Access Compliance Report Public Rights-of-Way (Curb Ramps)

Intersection ID: 14793	Main Street: BALTIMORE_AV	Cross Street: BENJAMIN_ST	Location: E
ADA ID: 6882416CDA4D	Ramp Type: PerpDiag	Initial Pass/Fail: Fail	Overall Compliance: No Severity Score: 35

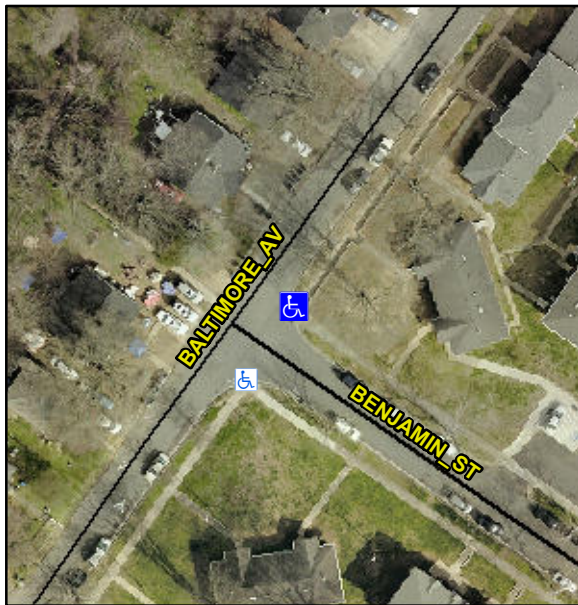
Not Found, R304.5.1, R304.2.2, R304.5.3

Compliance	Description	Data	Compliance	Description	Data
N/A	Ramp Length (in)	64.0	No	Ramp Slope (%)	15.4
No	Ramp Width (in)	38.0	No	Ramp XSlope (%)	2.8
N/A	Flare Type LT	N/A	N/A	Flare Type RT	N/A
N/A	Flare Slope LT (%)	N/A	N/A	Flare Slope RT (%)	N/A
N/A	Flare Traversable LT?	N/A	N/A	Flare Traversable RT?	N/A
N/A	Landing Length (in)	N/A	N/A	DWS Provided?	N/A
N/A	Landing Width (in)	N/A	N/A	DWS Contrast?	N/A
N/A	Landing Slope (%)	N/A	N/A	DWS Length (in)	N/A
N/A	Landing X Slope (%)	N/A	N/A	DWS Full Width?	N/A
N/A	Landing Curb? (Y/N)	N/A	N/A	DWS Offset (in)	N/A
N/A	Shared Landing?	N/A			
N/A	Gutter Ponding?	N/A	N/A	Gutter Slope (%)	N/A
N/A	Gutter Lip Ht (in)	N/A	N/A	Gutter X Slope (%)	N/A
N/A	Painted X Walk1?	No	N/A	Painted X Walk2?	No
	X Walk 1 Direction	To NW		X Walk 2 Direction	To SW
N/A	X Walk 1 Width (in)	N/A	N/A	X Walk 2 Width (in)	N/A
	X Walk 1 Slope (%)	4.9		X Walk 2 Slope (%)	0.2
	X Walk 1 X Slope (%)	1.9		X Walk 2 X Slope (%)	3.2

Remove & Replace Curb Ramp With Two New Directional Ramps or Equivalent.
